Re: Oxbow and Coors Pavilion Developments Traffic Impact Study

NMDOT has been working and reviewing the traffic impacts studies for the Coors Pavilion and the Oxbow development for several years. NMDOT has been working with the team since 2015 on Coors Pavilion. The last updated traffic impact study (TIS) was submitted in February 2022 for both the Coors Pavilion and the Oxbow Development.

NMDOT has reviewed the study from 2022 and has concerns regarding the density of commercial development utilizing the existing public roadway system with its limited roadway network system for its use. The proposed mitigation schematic drawing is attached. Our concerns are outlined below.

Proposed mitigation schematic drawing

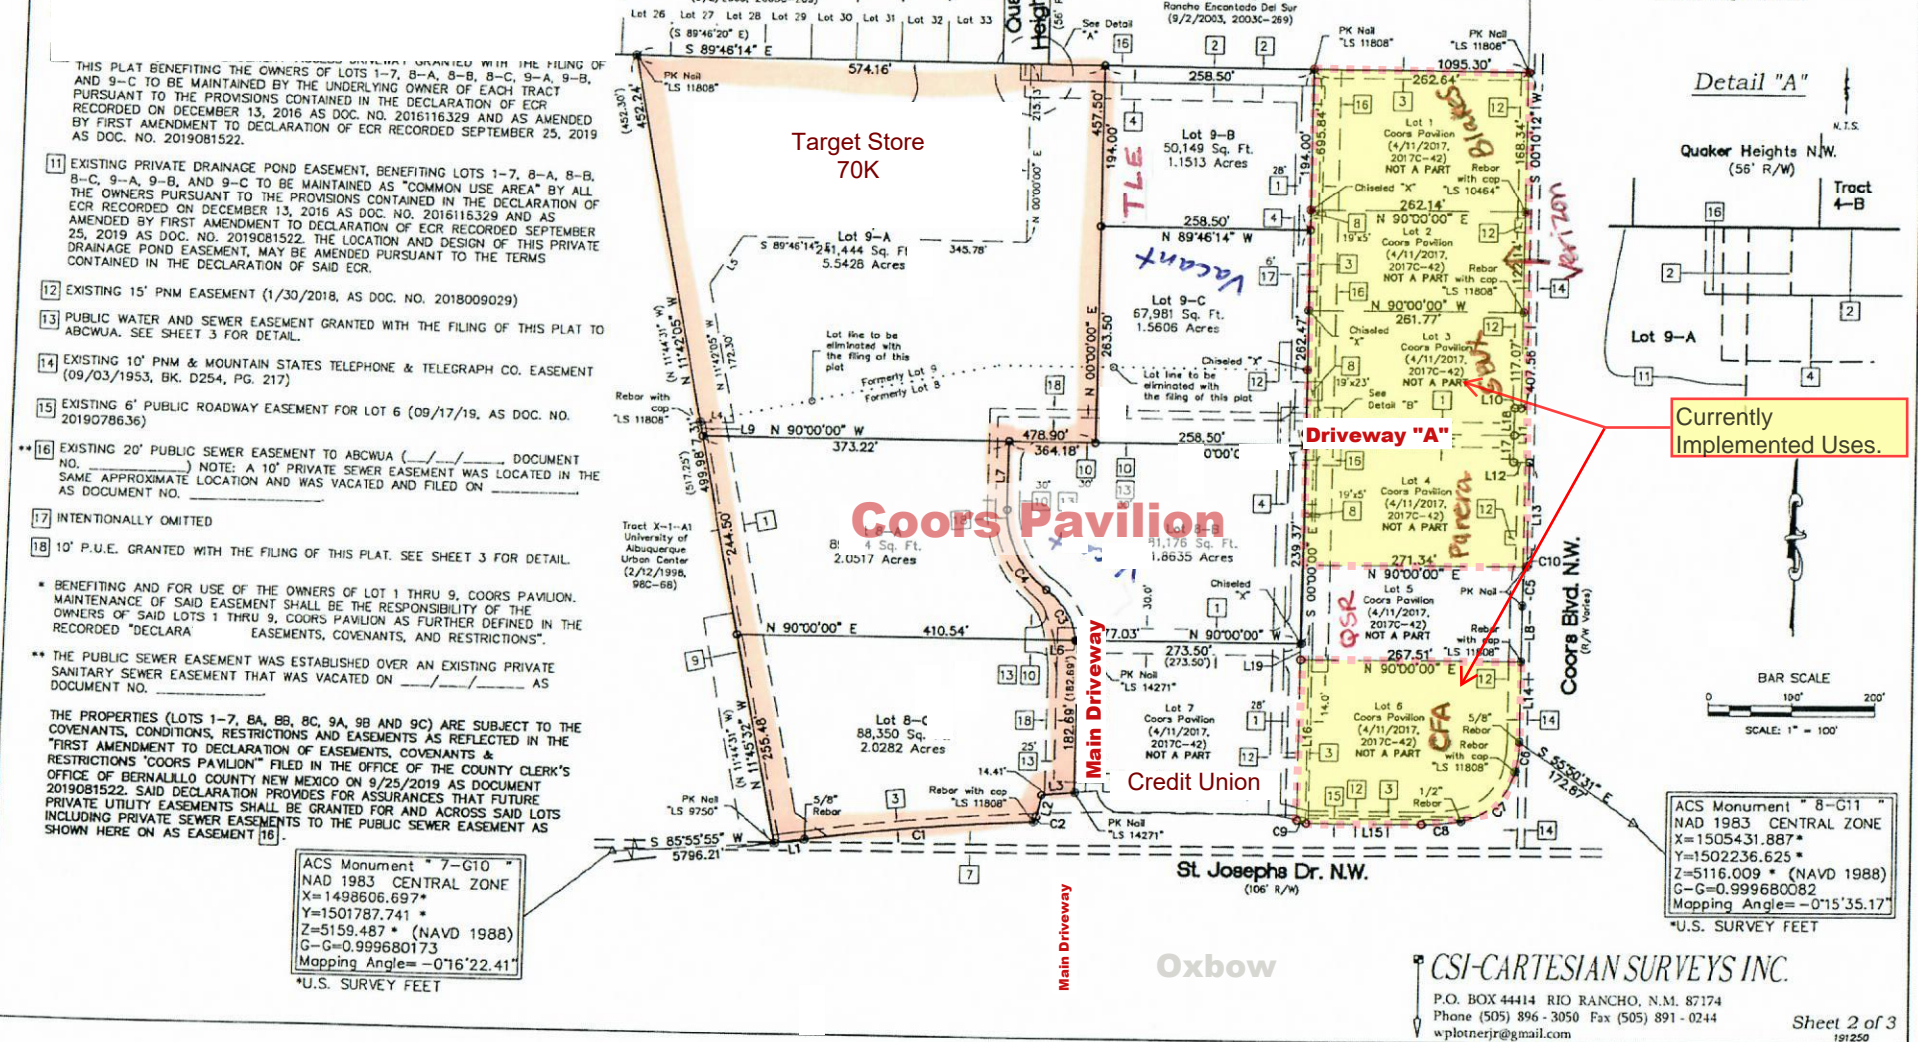
1. The proposed geometry used to develop the triple eastbound lefts for on St. Joseph's Drive at NM 45 should meet the SAMM redirect taper requirements.

2. All widening on NM 45 shall be from its centerline. The proposed geometry used to develop the dual northbound and southbound lefts on NM 45 at St. Joseph's Drive shall meet the SAMM redirect taper requirements.

3. The proposed full signalized intersection on St. Joseph's Drive and the main access to the developments is about 630 feet centerline to centerline. The next full intersection adjacent to a full signalized access shall be 1320 feet and 2640 if signalized. The access spacing does not meet SAMM corner clearance access spacing requirements.

4. The lane widths for northbound and southbound through lanes shall remain twelve (12) feet.
5. The divided median island width on NM 45 shall be a minimum six (6) feet in width.

6. The proposed triple left turns shall be designed to contain design vehicle WB-40 with two passenger cars with no over tracking in adjacent lanes.
7. NMDOT has concerns regarding signal timing operations for pedestrians with the proposed triple right eastbound left turn configuration.
